HISTORIC AND DESIGN REVIEW COMMISSION September 06, 2017

HDRC CASE NO: 2016-477

ADDRESS: 502 - 508 E GUENTHER ST

TYPE OF WORK: Removal of front yard turf and installation of gravel, xeriscaping

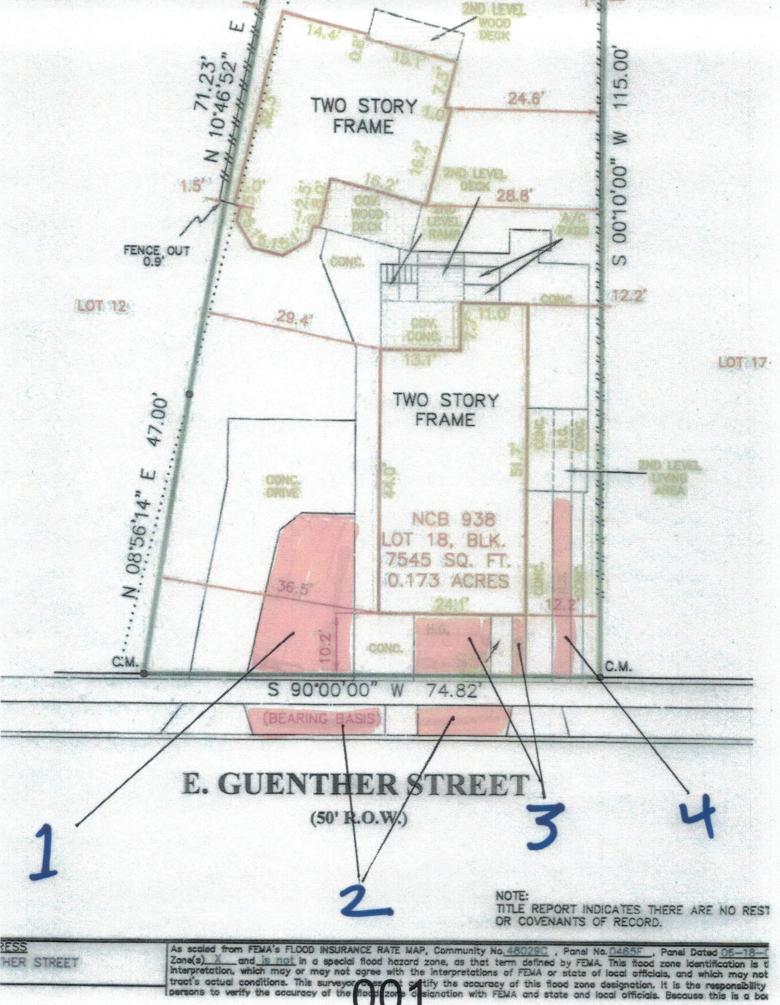
- c. At this time, the applicant has proposed to install plant materials including Ajuga, Dahlbert Daisy, Frogfruit and Winecups in the planting strip between the street and sidewalk and immediately in front of the primary historic structure, noted as areas 2 and 3 on the site plan. The applicant has proposed to maintain the existing, unapproved gravel between the concrete driveway strips and on the west side of the property, areas 1 and 4 on the site plan.

- d. Staff finds the installation of the proposed plant materials in the front yard, areas 2 and 3 to be appropriate. Materials in the planting strips vary along E Guenther. Additionally, staff finds the installation of gravel between the ribbon strips of the driveway to be appropriate. Staff does not find the installation of the gravel in area 1 to be appropriate. Staff finds the applicant should return this location to grass to adhere to the fifty percent of front yard grass requirement noted in the Guidelines for Site Elements, 3.A.ii.

i. That the applicant return area1, the western most portion of the site to natural grass or green landscaped area.

Staff recommends approval based on findings a through d with the following stipulation:
